ADDENDUM No. 2

ITB No. 4454

New Farmers Market Structure

NEW PERMEABLE BRICK PAVER SECTION (AT
DRIVEWAY APPROACH)
NOT TO SCALE

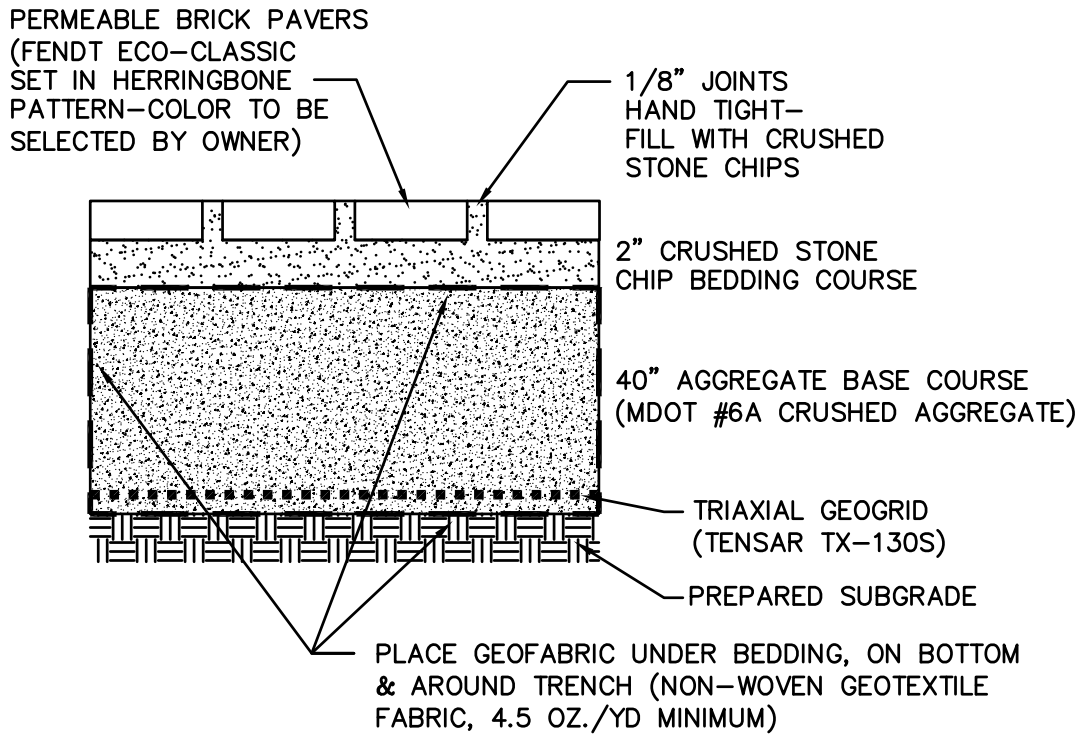
Question 6: Question about the 4” aggregate Base Course (MDOT #7A Washed Aggregate). Michigan Department of Transportation discontinued the use of MDOT 7A in 1957 from their specifications book. I was unable to find a product within our database that we could make that meets that old specification.

Answer 6: See new attached detail.

NOTE: CRUSHED CONCRETE IS NOT AN ACCEPTABLE AGGREGATE MATERIAL.
